Access Compliance Report

Public Rights-of-Way

(Curb Ramps)

Intersection ID: 45280	Main Street: LAKEHILL_RD	Cross Street: VALLEY_RIDGE_RD	Location: SW
ADA ID: 9720B131E057	Ramp Type: PerpDiag	Initial Pass/Fail: Fail	Overall Compliance: No
		Severity Score: 22.5

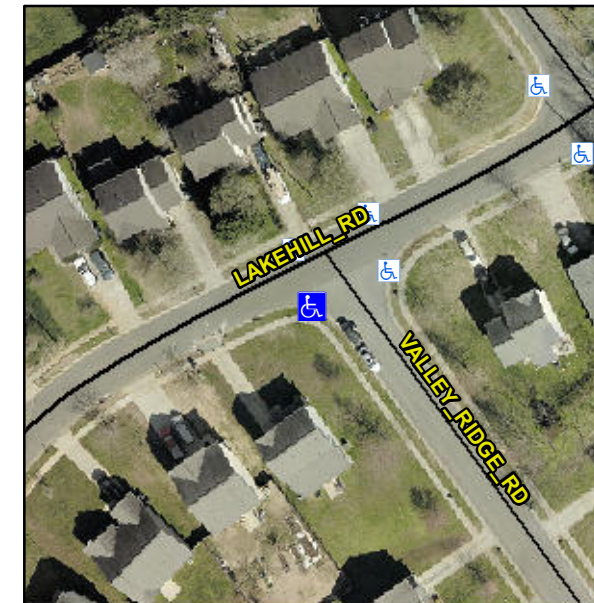
Not Found, R304.5.1, R304.2.2, R304.5.3

Compliance	Description	Data	Compliance	Description	Data
N/A	Ramp Length (in)	46.5	No	Ramp Slope (%)	8.5
No	Ramp Width (in)	43.0	No	Ramp XSlope (%)	2.7
N/A	Flare Type LT	N/A	N/A	Flare Type RT	N/A
N/A	Flare Slope LT (%)	N/A	N/A	Flare Slope RT (%)	N/A
N/A	Flare Traversable LT?	N/A	N/A	Flare Traversable RT?	N/A
N/A	Landing Length (in)	N/A	N/A	DWS Provided?	N/A
N/A	Landing Width (in)	N/A	N/A	DWS Contrast?	N/A
N/A	Landing Slope (%)	N/A	N/A	DWS Length (in)	N/A
N/A	Landing X Slope (%)	N/A	N/A	DWS Full Width?	N/A
N/A	Landing Curb? (Y/N)	N/A	N/A	DWS Offset (in)	N/A
N/A	Shared Landing?	N/A			
N/A	Gutter Ponding?	N/A	N/A	Gutter Slope (%)	N/A
N/A	Gutter Lip Ht (in)	N/A	N/A	Gutter X Slope (%)	N/A
N/A	Painted X Walk1?	No	N/A	Painted X Walk2?	No
	X Walk 1 Direction	To E		X Walk 2 Direction	To N
N/A	X Walk 1 Width (in)	N/A	N/A	X Walk 2 Width (in)	N/A
	X Walk 1 Slope (%)	3.1		X Walk 2 Slope (%)	4.4
	X Walk 1 X Slope (%)	4.1		X Walk 2 X Slope (%)	1.2

Remove & Replace Curb Ramp With Two New Directional Ramps or Equivalent.
